Stream buffer modification request and Buffer Enhancement Plan for the Smith Property

9746 Slater Road NE, Kirkland WA

ATTACHMENT 6
ZON06-00010

Re: Smith Stream Buffer Modification

HEAVY DUTY SEDIMENT FENCE

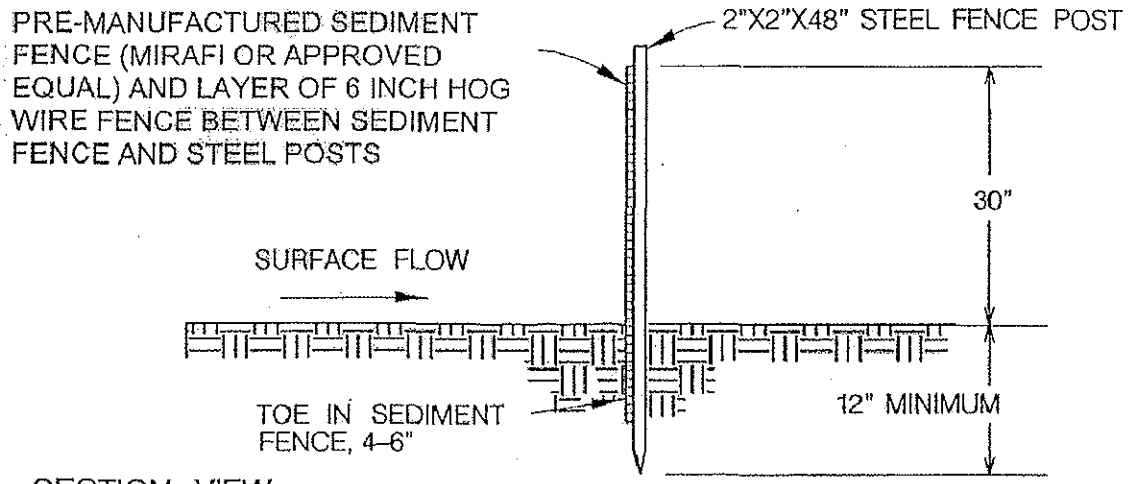
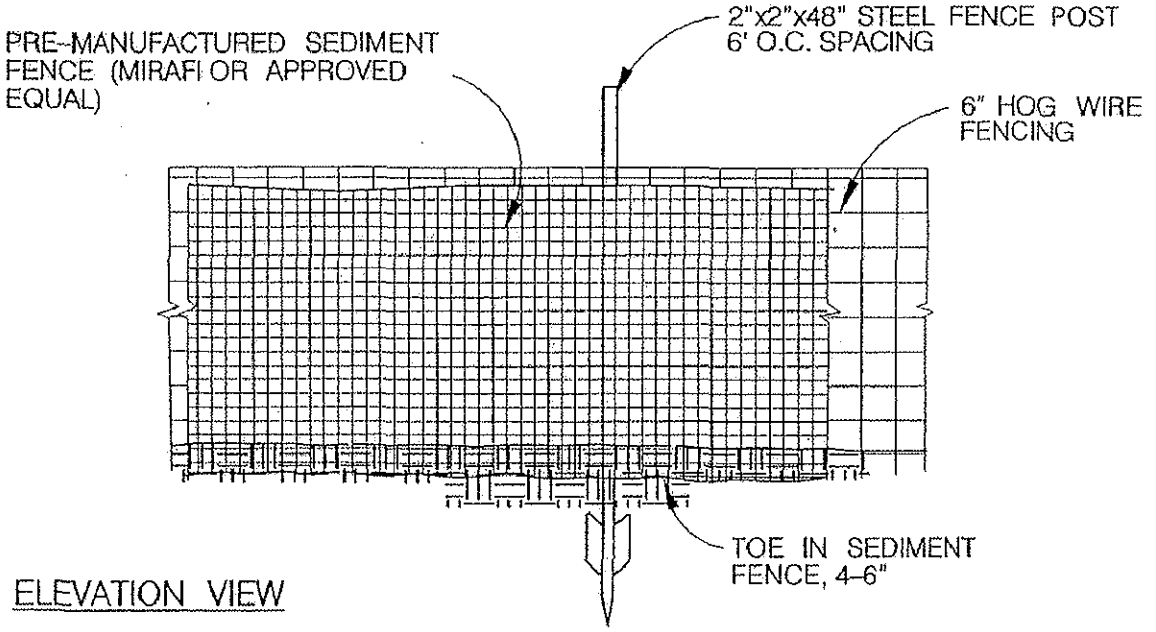
A few areas of the plan require revision. The plan includes mechanical removal of non-native vegetation below the top of the bank. This will very likely cause some stream disturbance. The plan contains no provision for this. Sediment fencing is proposed for the top of the bank, but no measures are specified to prevent erosion and sedimentation from below top-of-bank vegetation removal. The stream bank will also likely need to be stabilized after vegetation removal.

1) Submit a detailed plan for controlling erosion and sedimentation from work below top-of-bank. This should include plans for restabilizing the stream bank after vegetation removal.

SHEET NO.
L 1.0

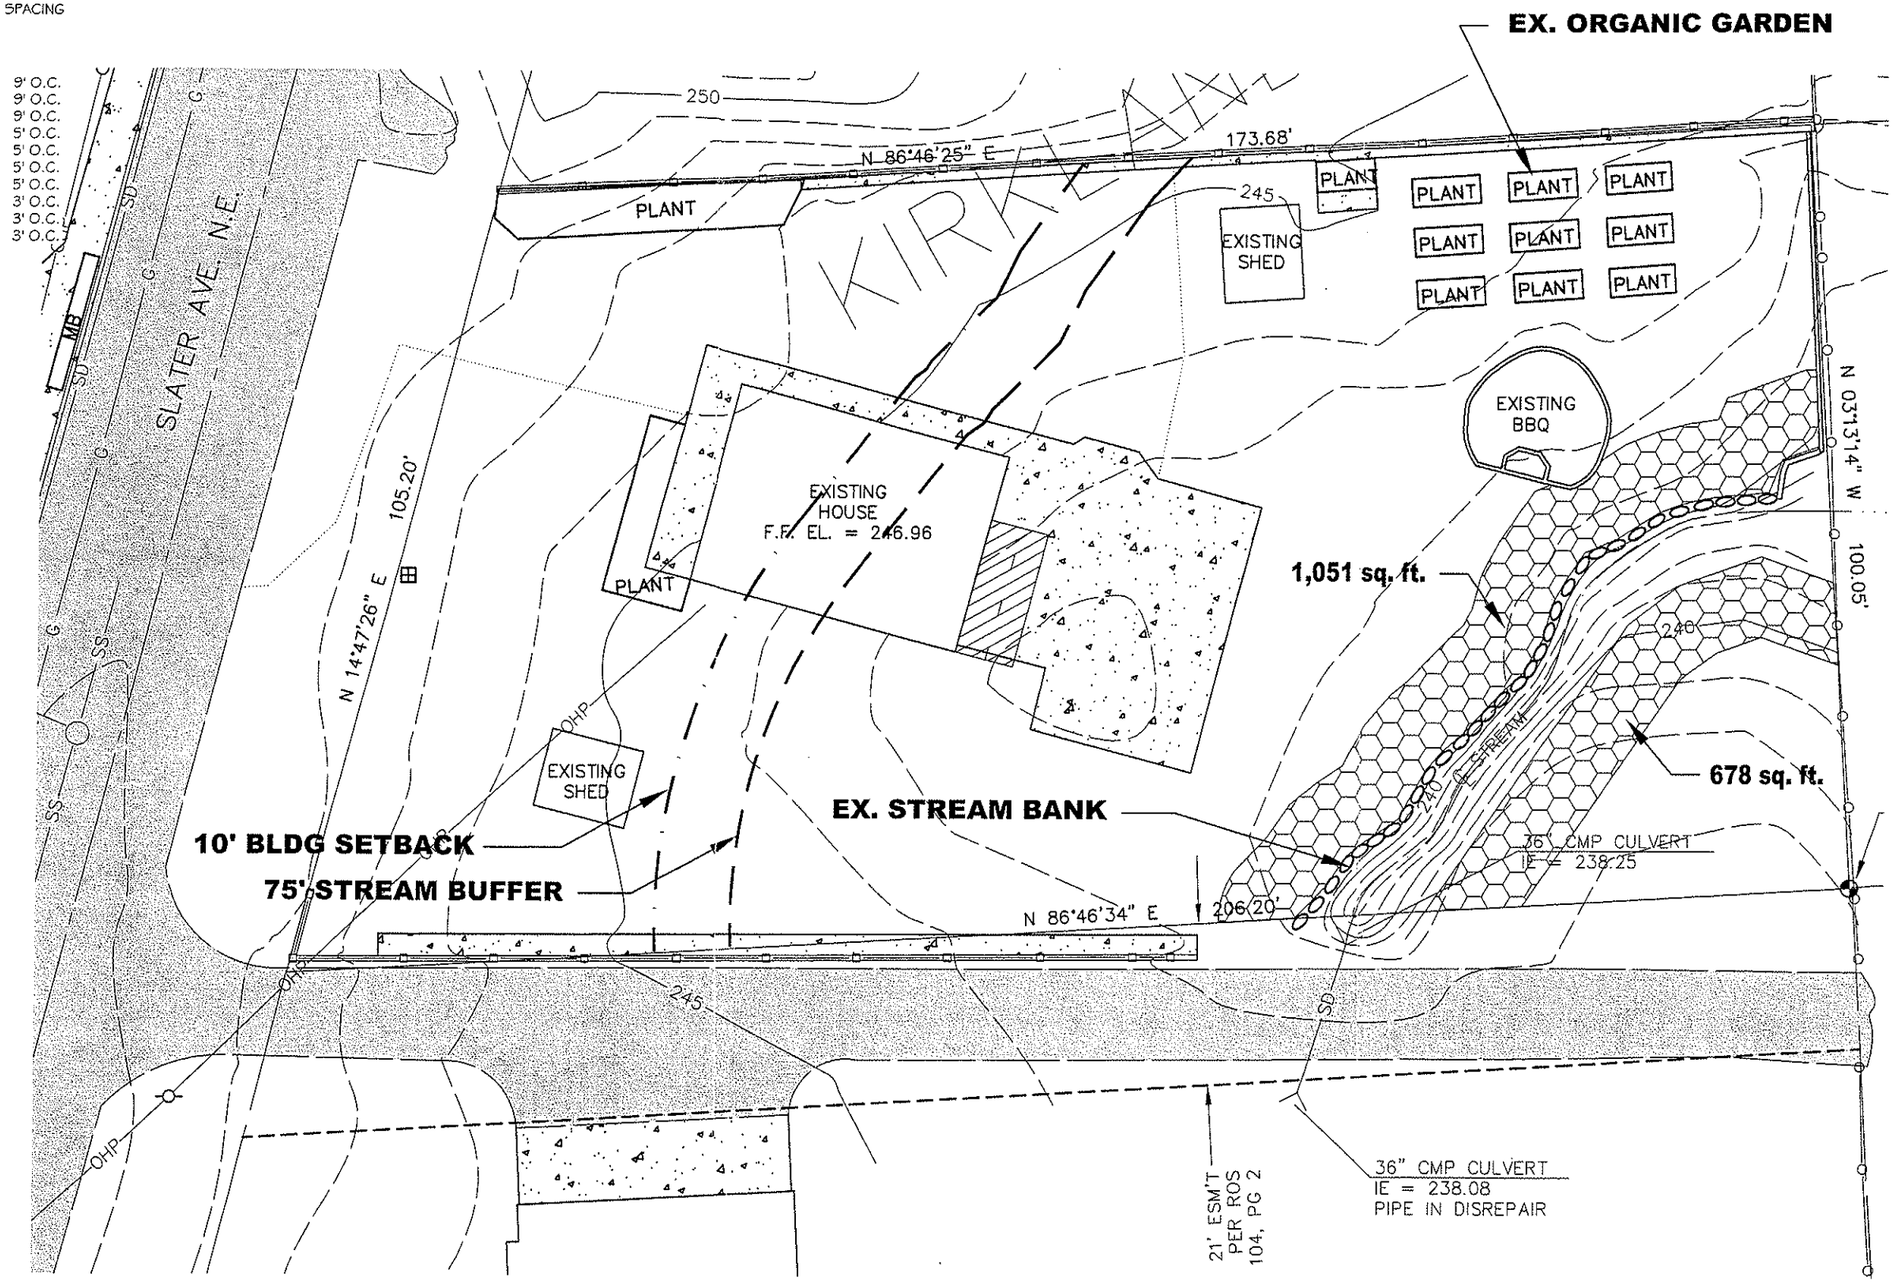
The text estimates the enhancement area at 1,900 square feet; the plan sheet shows total enhancement area to equal 1,729 square feet. Table 2 of the plan lists plant spacing as 9, 5, and 3 feet on-center for trees, shrubs, and ferns, respectively. However, the proposed number of plants is fewer than what would be required to achieve these densities in the typical triangular installation pattern. An area of 1,729 square feet would require 21 trees, 69 shrubs, and 192 ferns at the specified spacings. The plan proposes only 6 trees, 55 shrubs, and 28 ferns.

The plan calls for removal of non-native vegetation within the proposed 10-foot buffer enhancement area. On the bank on the side away from the landowner's house (right bank), invasive species dominate and have overgrown the stream itself. As proposed, the plan would leave invasive species in approximately 500 square feet adjacent to the 10-foot buffer. It is highly likely that these remaining plants will take over the enhancement area on the right bank soon after the maintenance period ended. If all invasive species on this side were removed to the

2) Revise the plan text and drawing to show the accurate square footage of the enhancement area.
3) Recalculate the number of plants needed for the spacing specified in Table 2 using the following per-square-foot multipliers: 0.012 for trees, 0.040 for shrubs, and 0.111 for ferns.

4) Include plans for removing invasive vegetation to the property line on the right bank.
5) Consider planting the entire slope on the right bank, both for stability and to prevent reinvasion of non-native species. At a minimum, areas of weed removal should be seeded.
